<b>Docket Number:</b>	18-IRP-01
<b>Project Title:</b>	Integrated Resource Plan
<b>TN #:</b>	231654
<b>Document Title:</b>	Updated - Staff Report - Review of Glendale Water and Power's 2019 Integrated Resource Plan
<b>Description:</b>	This document supersedes TN# 230855
<b>Filer:</b>	Courtney Wagner
<b>Organization:</b>	California Energy Commission
<b>Submitter Role:</b>	Commission Staff
<b>Submission Date:</b>	1/23/2020 3:59:20 PM
<b>Docketed Date:</b>	1/23/2020

# **Review of Glendale Water and Power's 2019 Integrated Resource Plan**

**Gavin Newsom, Governor**  
**November 2019 | CEC-200-2019-019**

**Figure 2: Glendale and CEC Peak Forecasts 2019-2030 (MW)**

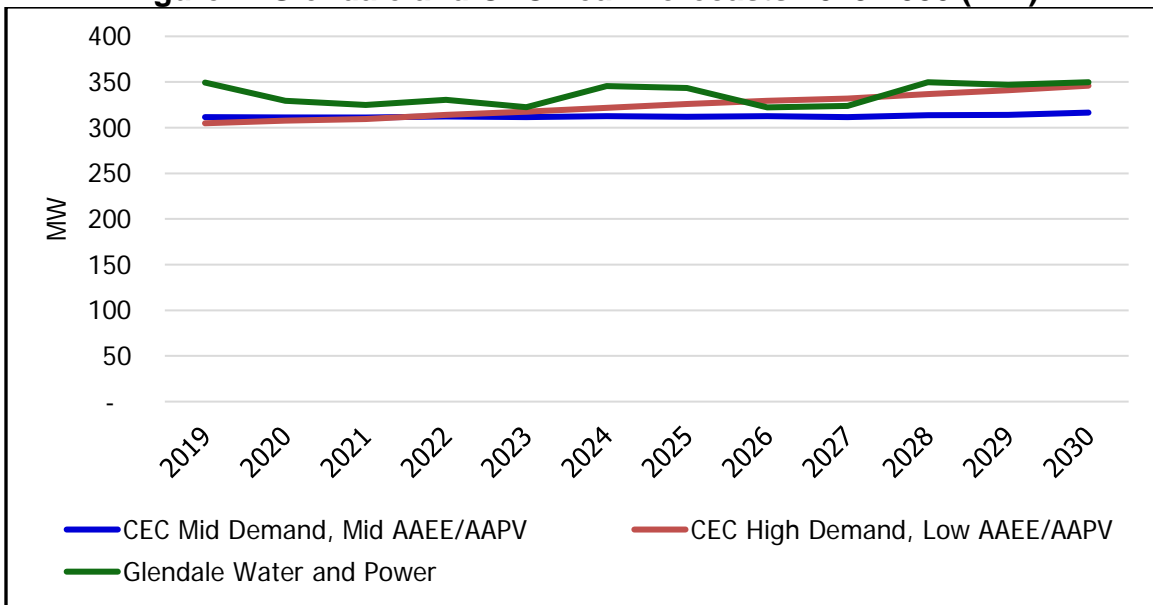
As can be seen in **Figure 2**, the forecasted peak demand is typically above the *2018 IEPR Update* high-demand, low-AAEE/AAPV forecast. This is likely due to a difference in assumed load shape.
